PLANNING COMMISSION AGENDA

- Downs Preliminary Site Plan Review

CITY OF NORTHVILLE
Northville City Hall
215 W. Main Street, Northville MI
Planning Commission Meeting Minutes
May 17, 2022
6:30 PM

MEMORANDUM: Preliminary Site Plan Layout Revisions

OVERALL SITE PLAN

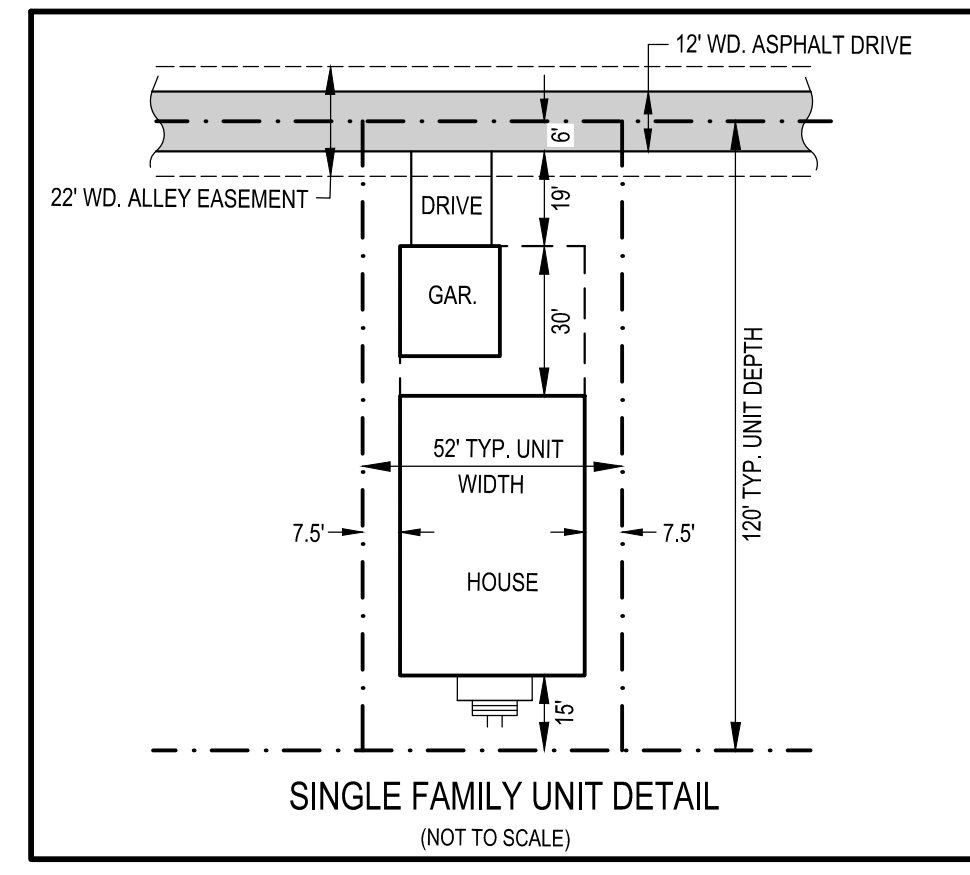
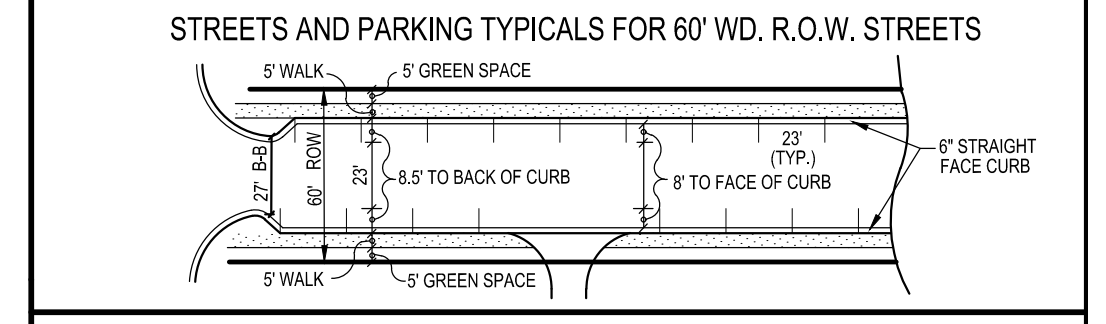
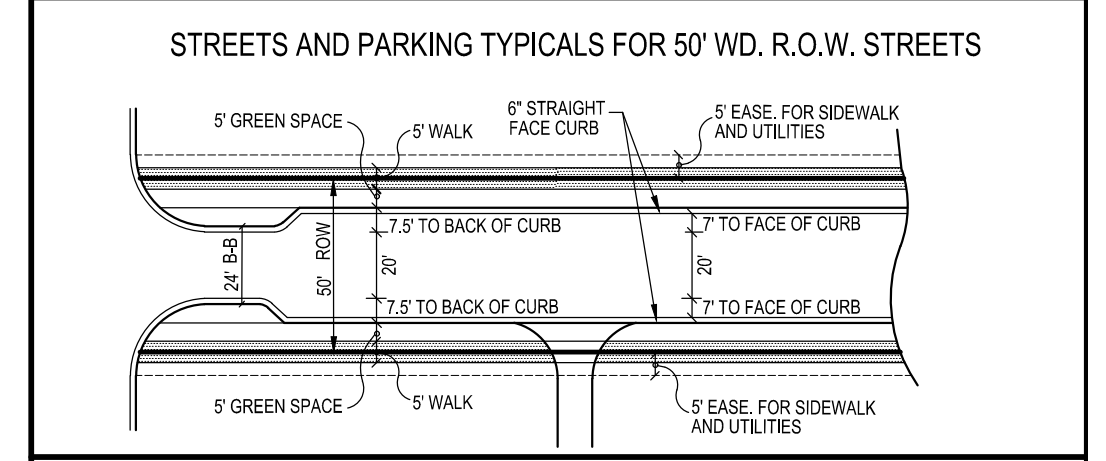
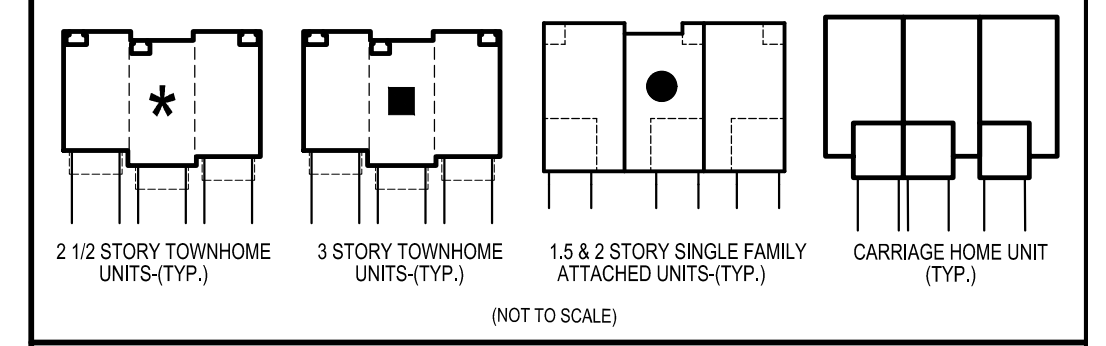
In response to comments during the recent Planning Commission Site Plan Review meetings, we have made several revisions to the Site Plan for the Northville Downs Development. Please see the attached revised Overall Site Plan (Sheet 7 of the PUD Site Plan Set) for review and discussion. The following memorandum discusses the revisions made to the Site Plan:

1. As discussed in the May 17 Planning Commission Meeting, all the Public ROW south of Beal Street is 50 ft wide. The road cross sections have been revised to provide 10' wide drive lanes with shared bike lanes, 7' wide on street parking spaces, a 5' wide greenspace behind the curbs and a 5' wide sidewalk. Adjacent to each ROW line, there is a 5' wide "Easement for Sidewalks and Utilities" provided to allow adequate room in and adjacent to the ROW for public sidewalks and utility installations. 24" Straight Face curbs are provided in all public ROW's as requested.

3. Additional hardscape has been provided at the Apartment and Condominium buildings along Cady Street. Please see the Landscape Plans for additional details.

OPEN SPACE PLAN

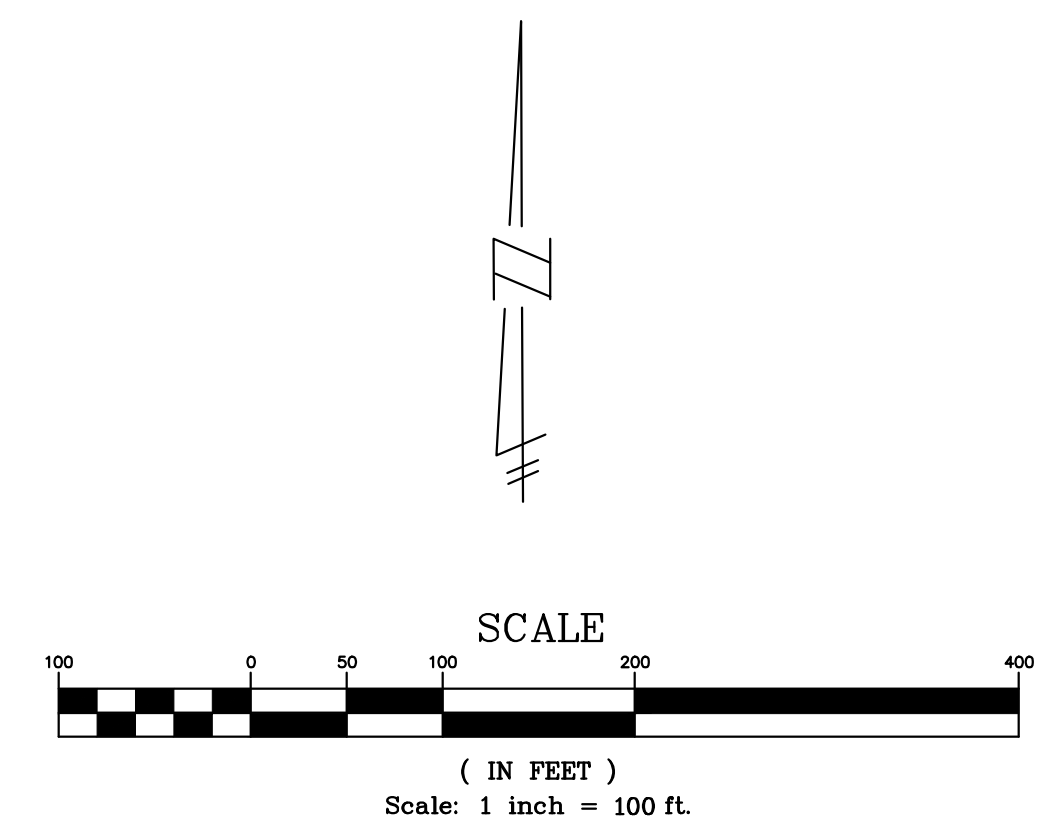
Added 3 pocket parks along S. Center Street. The applicant should provide the calculation for the amount of open space.

- Incorporation of new 38-foot wide pocket parks, at Center and Fairbrook, and at Center and Beal. Over 30% of the site plan is dedicated open space.
- Extended the setbacks along Center and Beal from 15’ to 20’. The increased setback helps address concerns regarding the canyon effect along Center. An ancillary benefit of the extended setback is an increase in the greenbelt along both Beal and Center streets.

OPEN SPACE SUMMARY	
SITE AREA	48.12 ACRES
OPEN SPACE SHOWN	14.94 ACRES
OPEN SPACE PERCENTAGE	31.05%
OPEN SPACE EXCLUDING DETENTION	12.18 ACRES
OPEN SPACE PERCENTAGE	25.31%
OPEN SPACE AS SHOWN ON MASTER PLAN	9.31 ACRES (19.3%)

Here’s the recent Downs Site with OHM Sheldon-Center/Seven roundabout (WIP, I’m sure)...

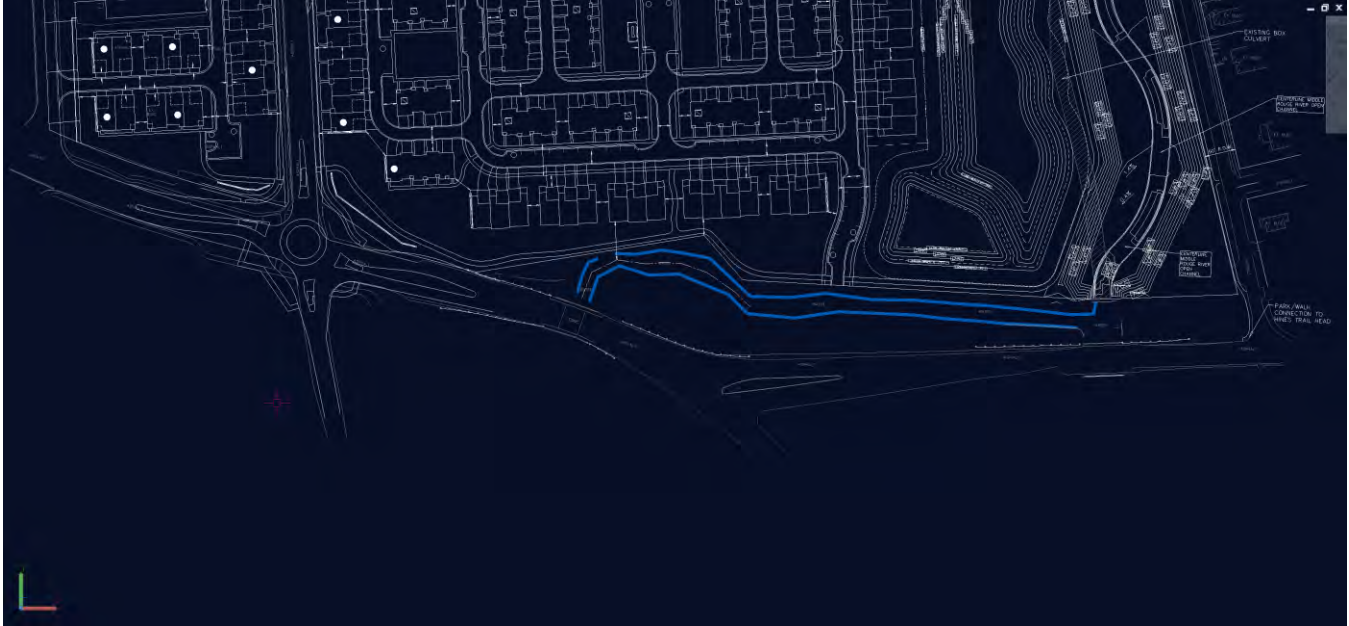
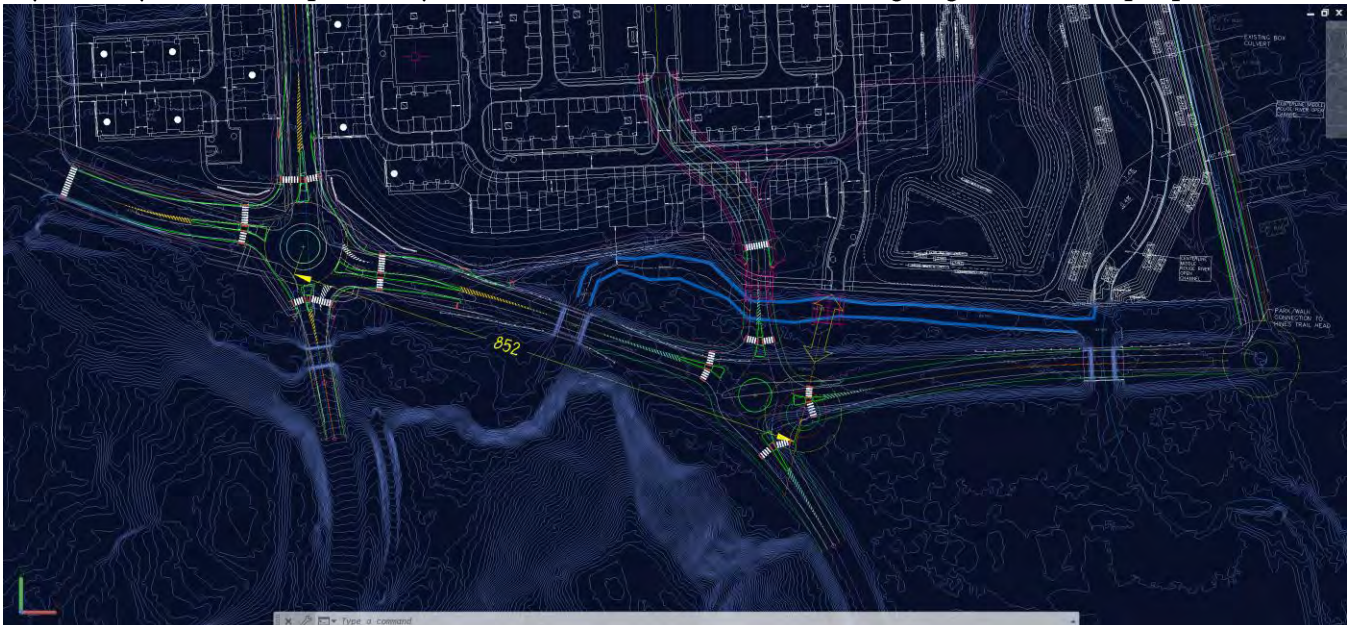
PS3: Mr. Salliotte asked a great question at PC about the connection at Hines-Downs/Seven, considering Hutton versus New Griswold pathing. I called it a ‘natural’ small adjustment. The following may be clearer than my words were then, and perhaps interesting as roundabout context.

My January, 2020 concept overlaid. Notice Seven/Johnson Crk. bridglet gets room for people & bikes.

I was having fun with roundabout geometry, playing with bicycle bypass best practices at Center and going for KISS at Hines. On a page width view you can see the existing roadways, the Ski Jump Hill terrain, and the Johnson Creek Bridglets as they define the geometry. A strong S-Curve was needed to line up with Hutton. The double-arrow shows a small shift to New Griswold that works better for all.
